**PLANNING COMMISSION AGENDA
SEPTEMBER 19, 2019 – 6:30 P.M.**

**Planned Unit Development (PUD)—
Brixmor Property Group, LLC**

RE: Planned Unit Development (PUD) Amendment
Initial Review
Brixmor North – Southport West

Comment Response: PUD Brixmor North

drawn by: JLC
 checked by: EW
 approved by: OA/CC
 project no.: 019-1124
 drawing no.: 06.03.19
 date: 06.03.19
 SHEET C.2.1

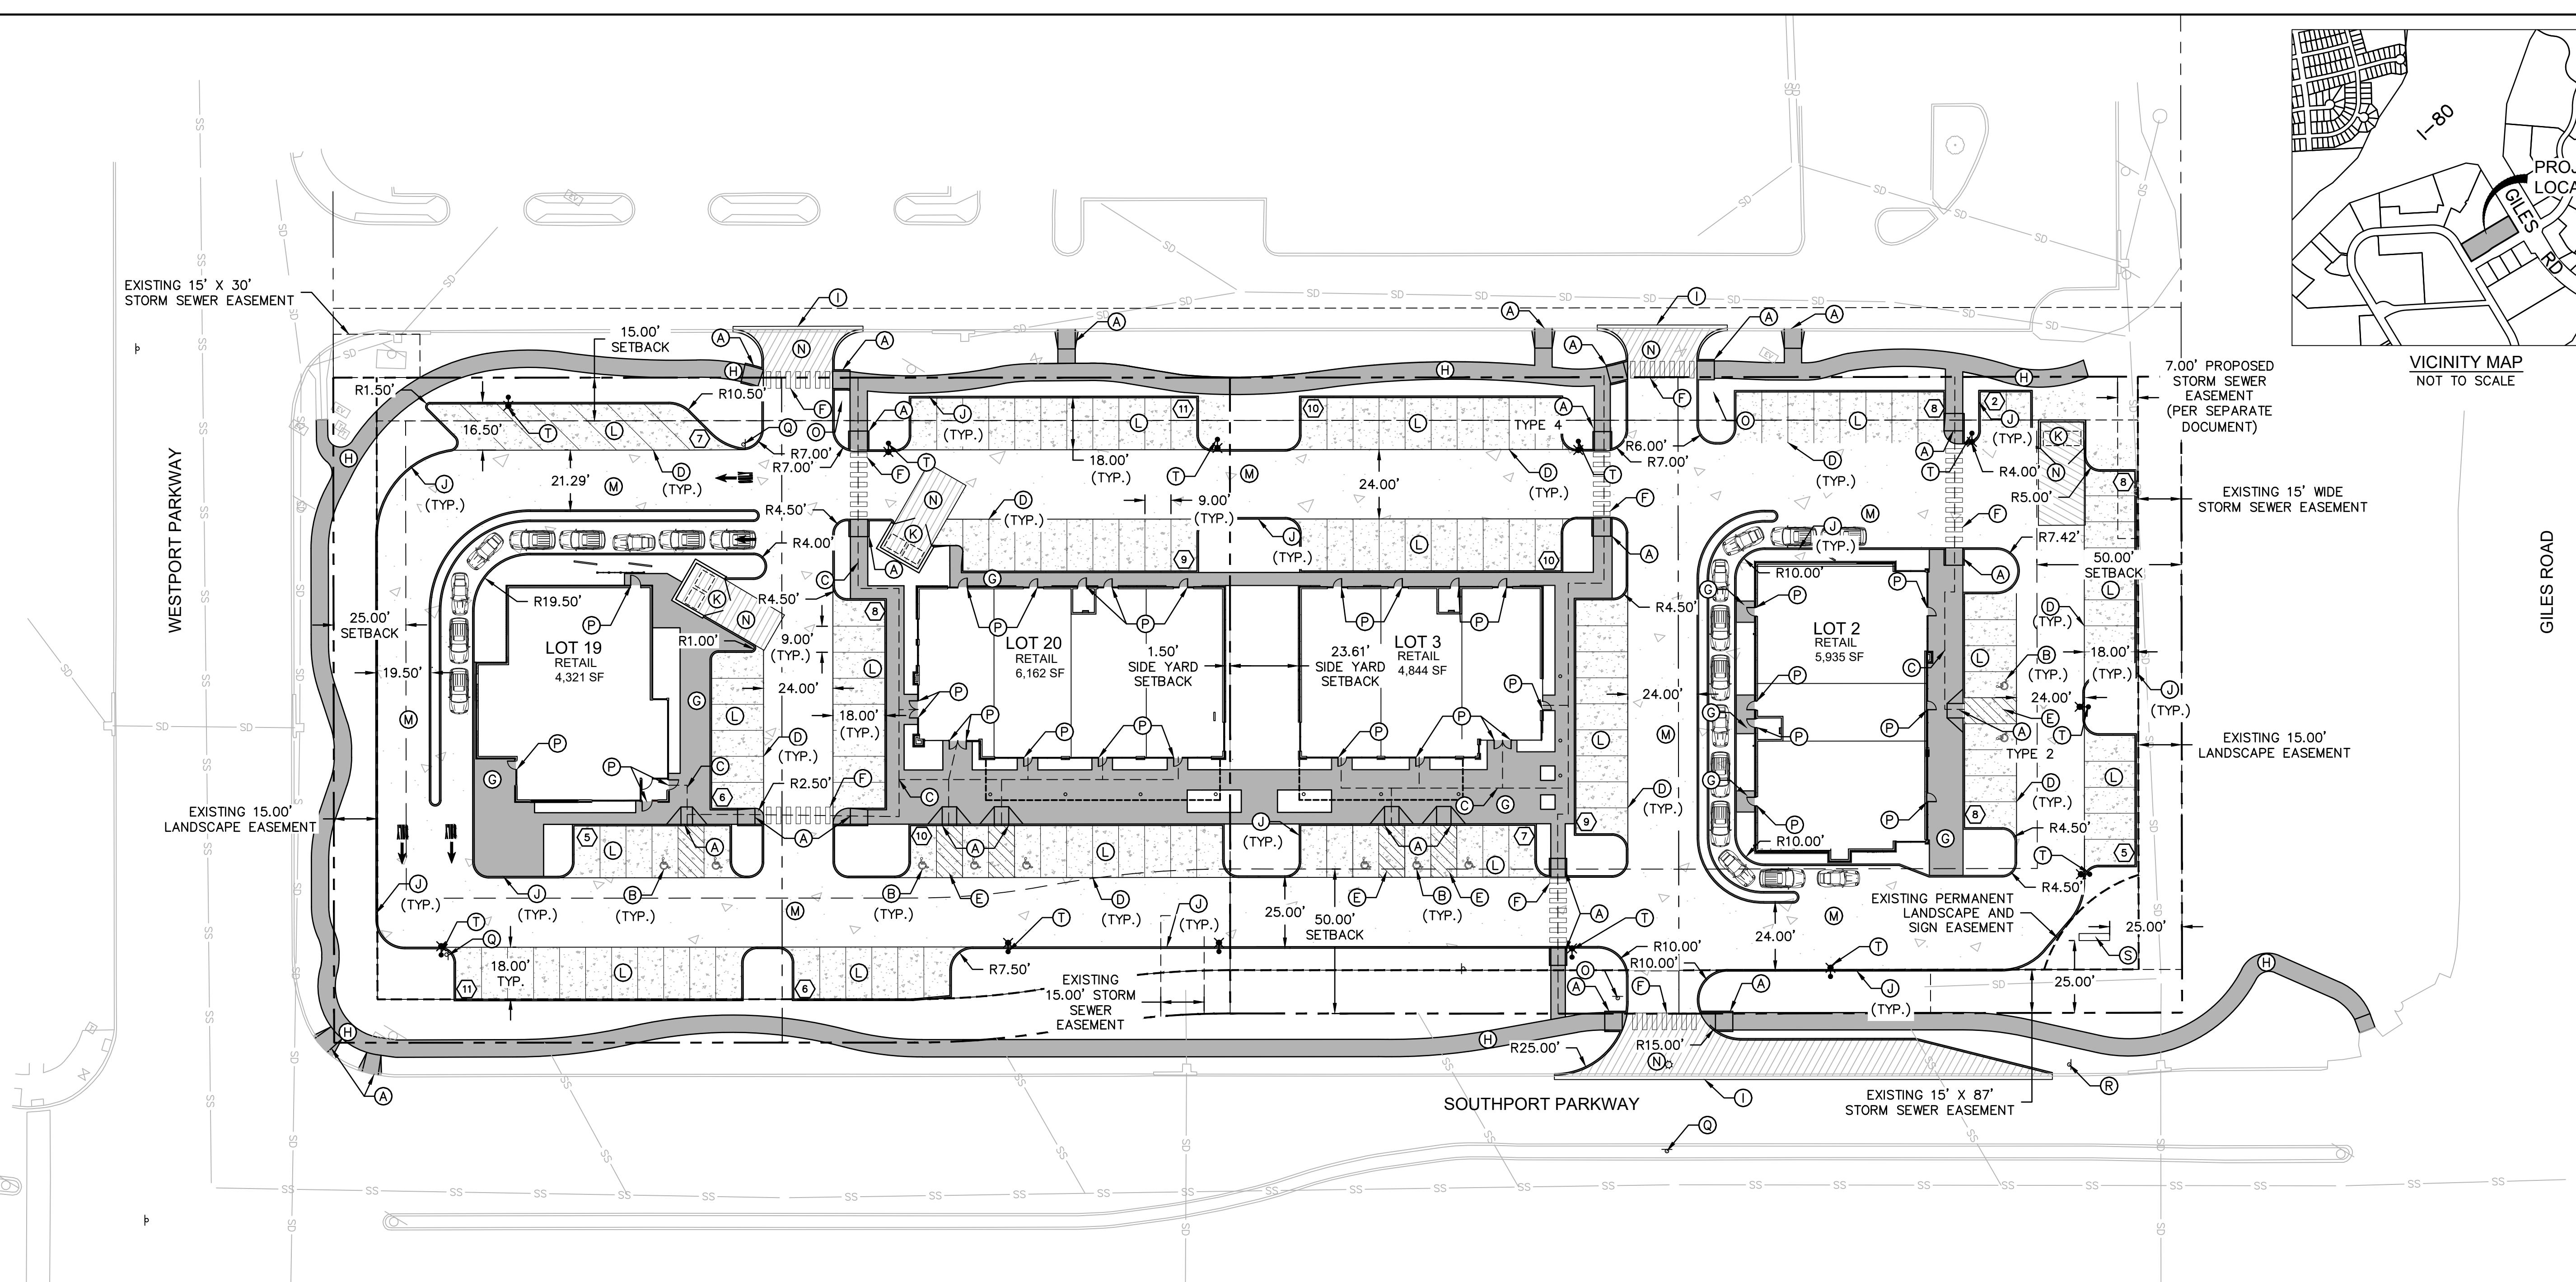
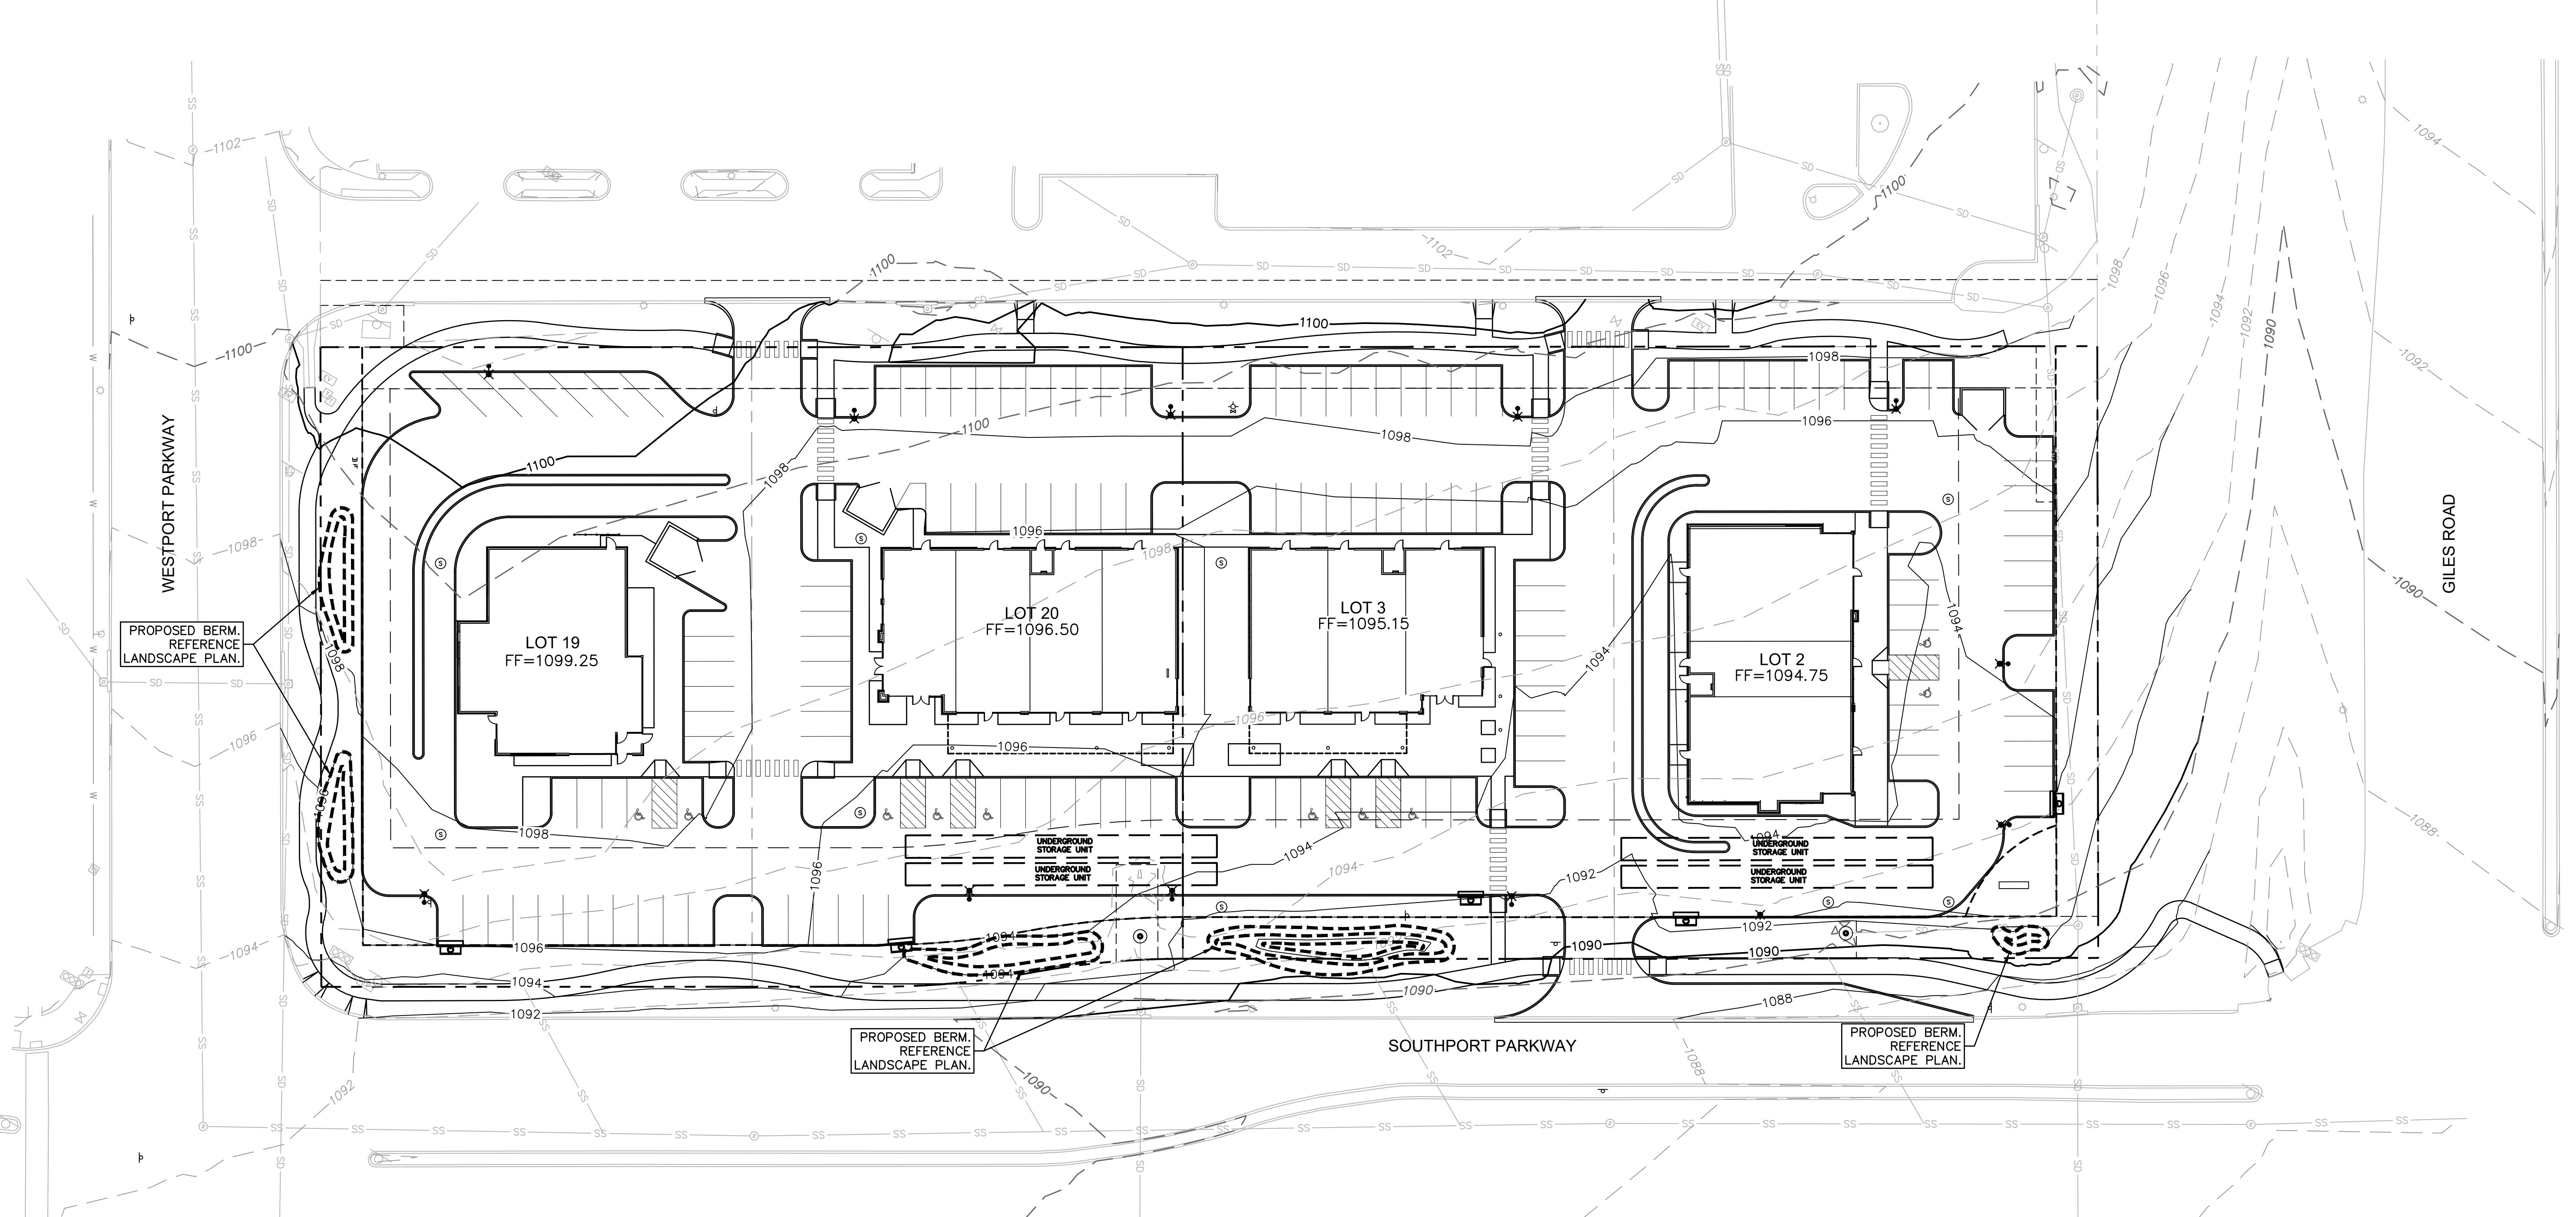
Sheet C2.1

- Parallel parking stalls in front of 4,844 sf building are too small and will potentially add congestion. Confirm parking count is adequate per building use.

- Proposed building on Lot 20 does not meet the 15 ft side yard setback of the C-3 District. Dimension proposed setbacks from the side yard lines.
- Building coverage does not appear to be an issue, but data should be set forth on the site layout plan to show compliance with the 60% limitation to conform with Article 5.15.04.10.
- Proposed locations for potential project directory or center identification signs need to be shown

Sheet C2.1

- Proposed public sidewalk needs to be 6 inches thick and not closer than 6 feet to back of curb. **Response: Notes have been revised.**

- Pavement thicknesses in the Site Key Notes need to be filled in. **Response: This has been completed.**
- Need dual ADA ramps at Southport Parkway and Westport Parkway intersection (currently only one ramp is shown). **Response: Ramps have been revised.**

- Walk connections to hotel not shown. **Response: Connection to the hotel has been added.**
- Walk connections to public sidewalk not shown. **Response: Connection to public sidewalk have been provided.**

- Traffic circulation to the buildings with drive-up windows needs clarified, appears that one-way traffic may be intended but not clearly shown. **Response: The site has been modified to provide a 3' island for separation of drive-thru traffic and circulating traffic.**

- The drive-up lane at rear of bldg. on Lot 2 needs barrier from inbound traffic to avoid confusion/accidents. **Response: The site has been modified to provide a 3' island for separation of drive-thru traffic and circulating traffic.**

- Parallel parking stalls in front of 4,844 sf building are too small and will potentially add congestion. Confirm parking count is adequate per building use. **Response: This parking has been removed and parking counts provided.**

- Radii at the proposed RIRO access on the interior turns should be greater. **Response: This has been revised.**
- The Site Information Table lists the existing and proposed zoning as "MU". Both should be listed as "C-3 PUD with a Gateway Corridor Overlay". **Response: This has been revised.**

Ordinance 1267 states that building setbacks shall meet C-3 zoning unless otherwise approved by City Council as part of the final PUD. The setbacks in the site information table and on the map of C2.1 need to depict the setbacks set forth within Section 5.12.06.01 of the Zoning Ordinance. Specifically, The building setback dimension along Giles Road and Southport Parkway needs to be adjusted to 50 feet; 25 feet along Westport Parkway; and 15 feet along the property line shared with the hotel. **Response: Setbacks along the roadways have been revised and noted.**

SHEET
C3.1

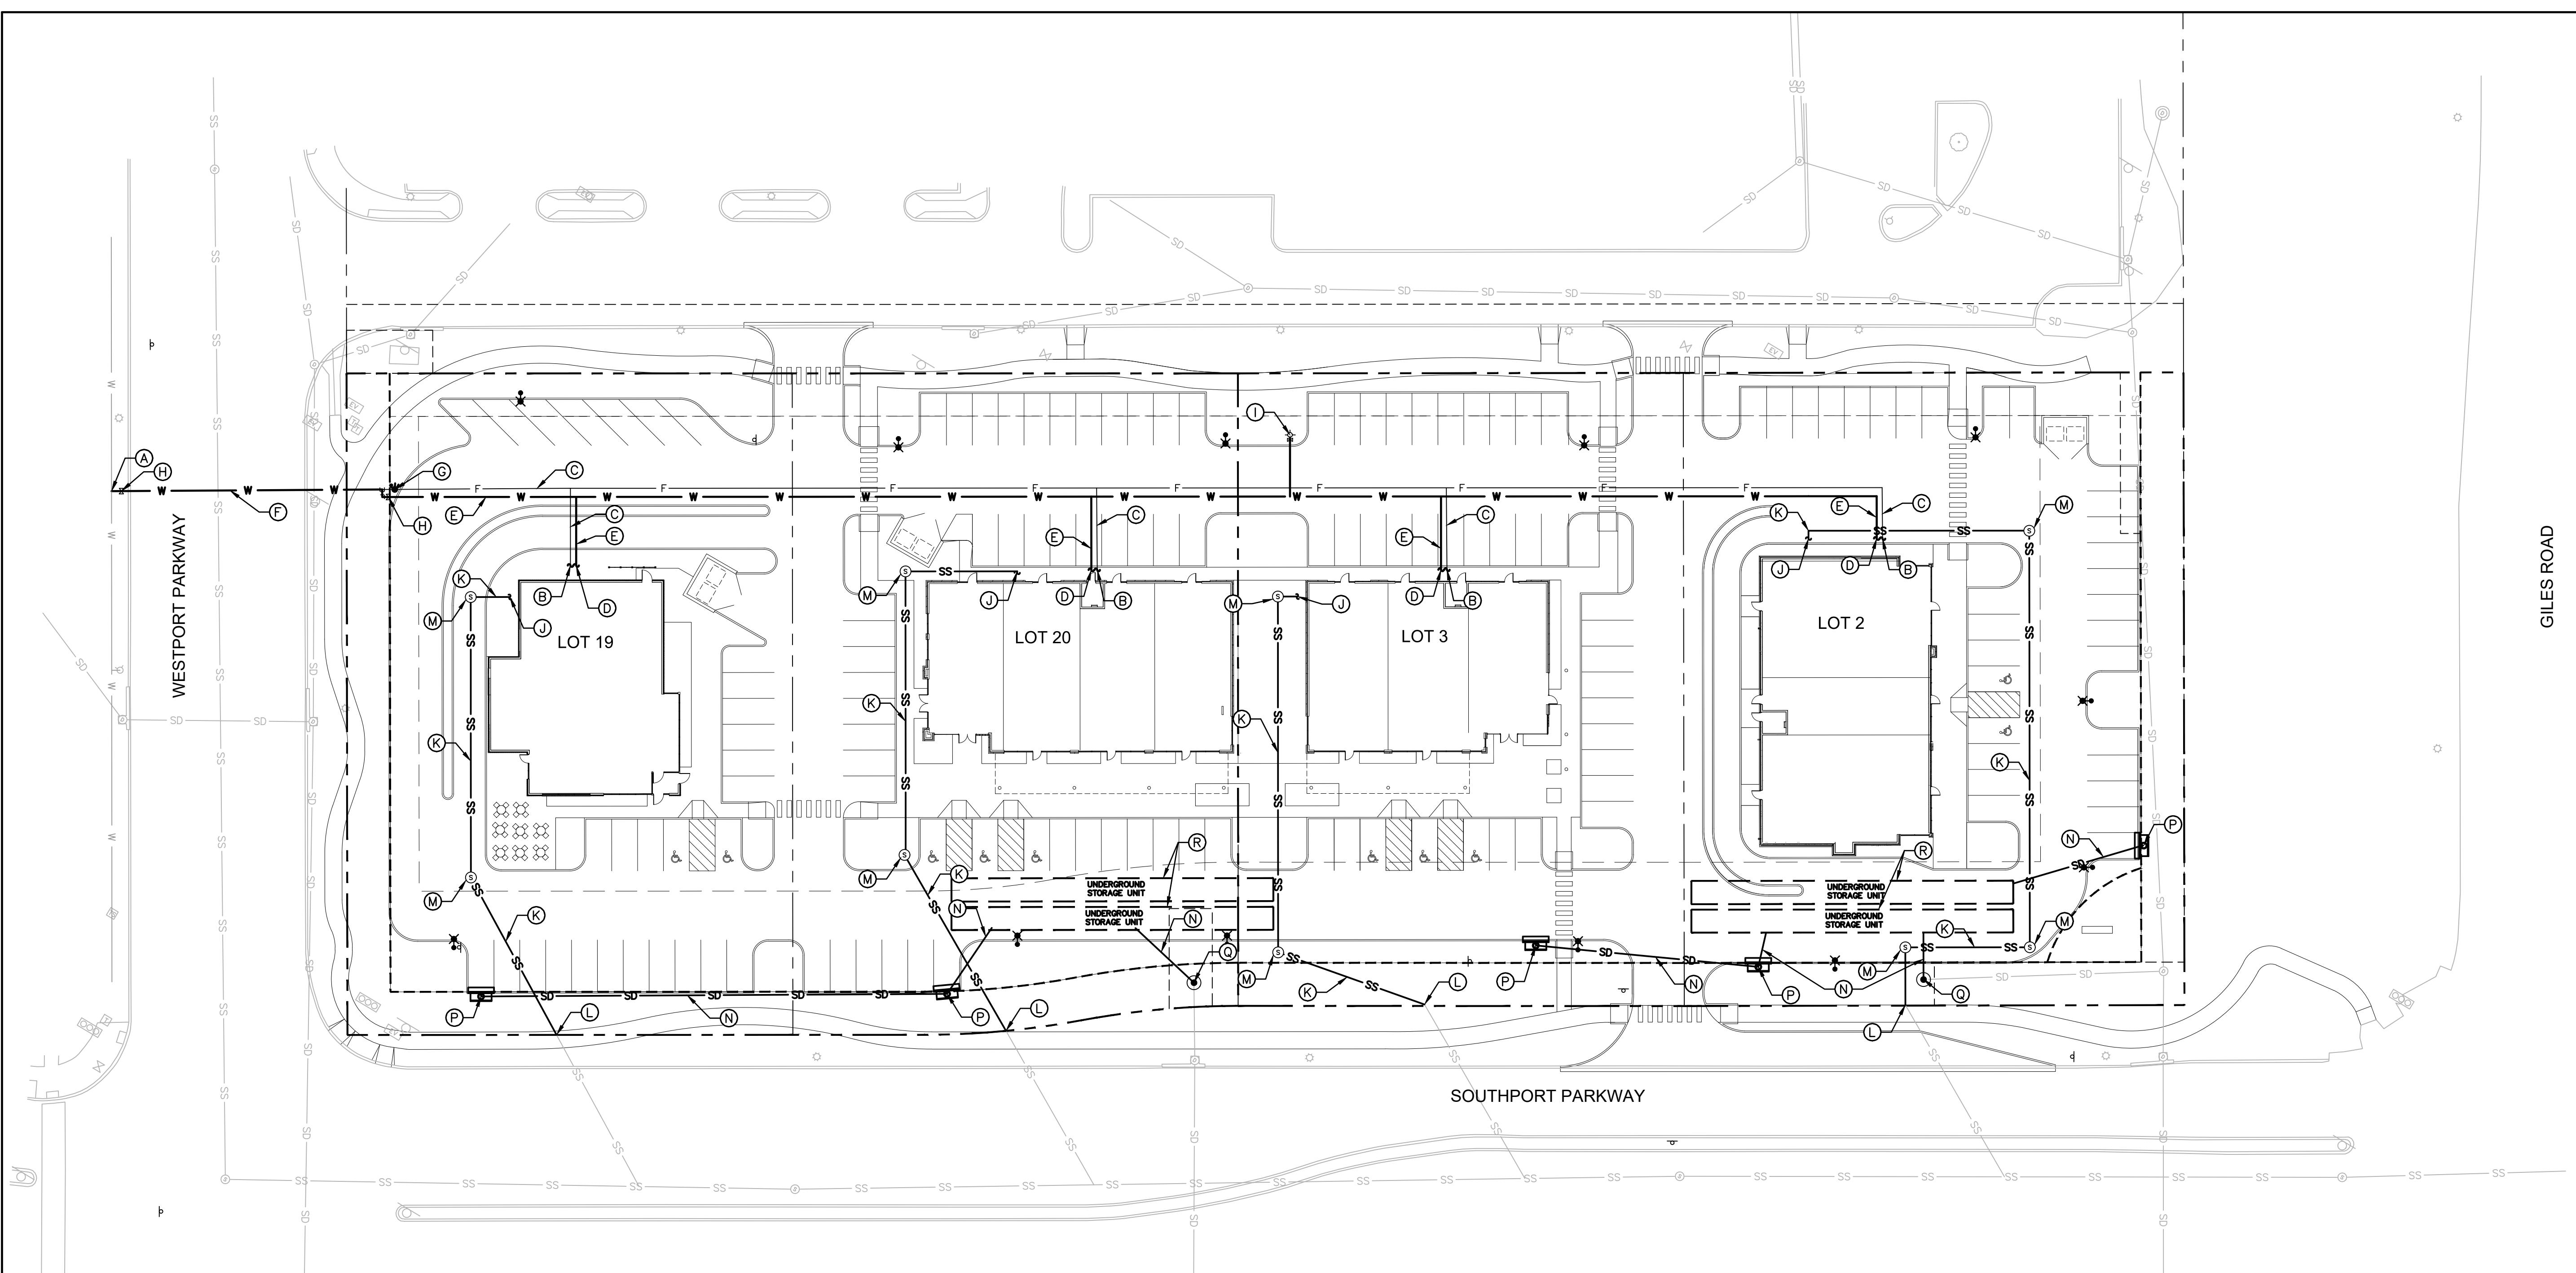
- Grading work will require a grading permit. Refer to the Master Fee Ordinance for details.
- Grading plan needs to address a conceptual design of water quality and 2-year peak flow detention, such as indication of bio-basins or under parking lot facilities.
- As there are drainage capacity limitations at the culvert crossing near under the rail road southeast of Giles road, all catchments drain that drain into said basin should be held to a no-net increase of the predevelopment flows until the drainage culverts at the railroad is up-sized to account for post-developed conditions for a 100-year return frequency.
- The grading plan submitted does not depict the required berthing of the landscaped areas along Westport Parkway as required per Section 8(B)(ii)(c) of the Southport West PUD.
